A G E N D A

Architectural Review Board

August 24, 2021 – 5:30 p.m.

1212 Westmoreland Avenue

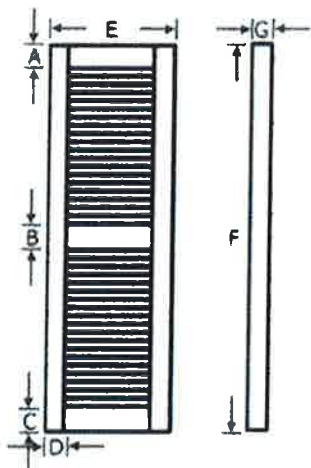
- This house was built in 1986
- The shutters are appropriately dimensioned, no objection.

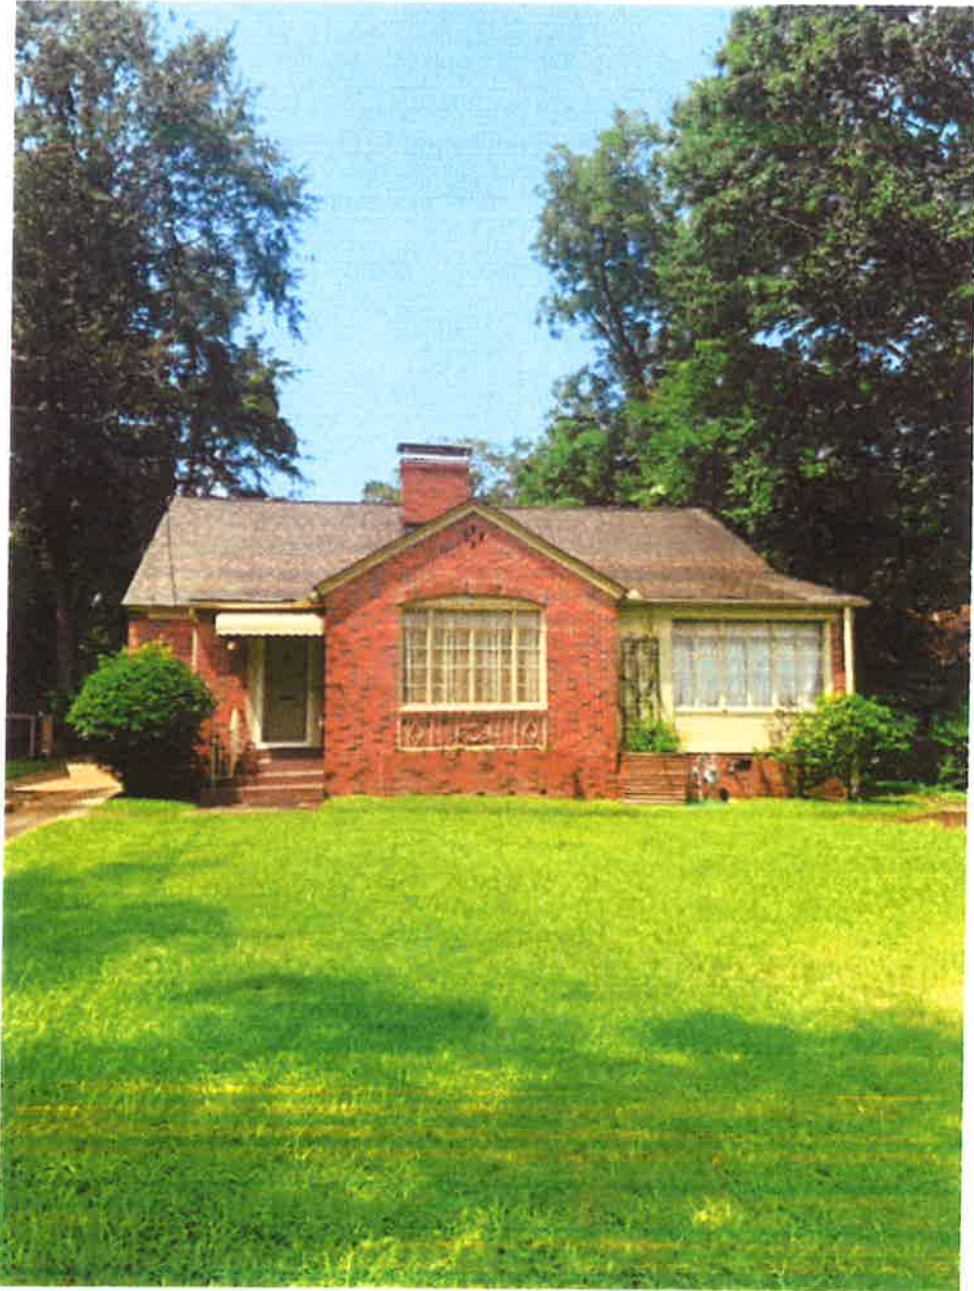
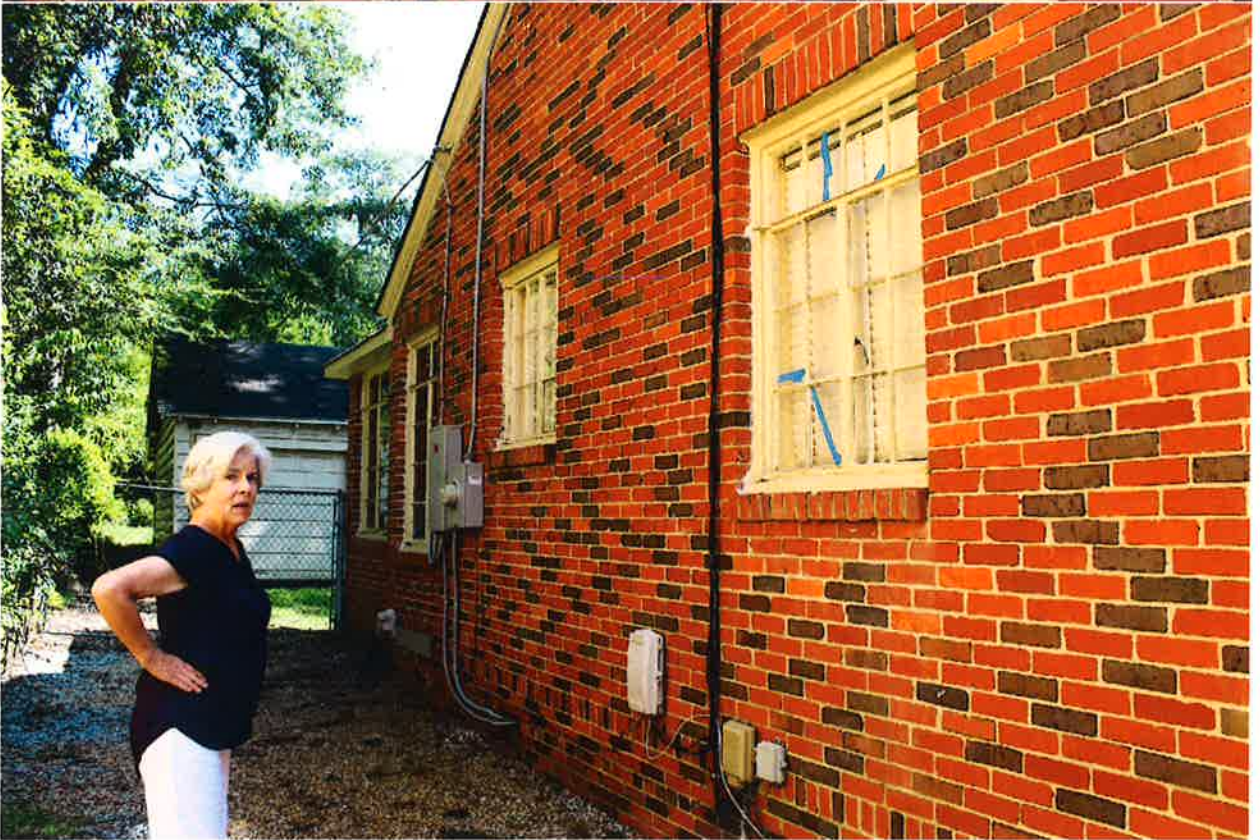
REMARKS: Ms. Tackett's house was built in 1939, and has large banks of steel casement windows throughout. The steel is rusting and expanding, so much so that it has and continues to crack panes of glass. In the 7 years she has owned the house (and we have discussed the windows on multiple occasions in the last several years), she has spent approximately \$9000 on their maintenance—replacing broken glass, reglazing and repainting the frames, but the deterioration continues. Ms. Tackett is proposing Weathershield casements and/or casement/fixed window combinations to closely duplicate the appearance on the street frontage. She would like to know if the board would consider Weathershield casement and fixed windows with no lite configuration to replace windows on the other elevations. As the house is situated, the only thing visible from the street is the front elevation. The current windows also do not meet egress code.
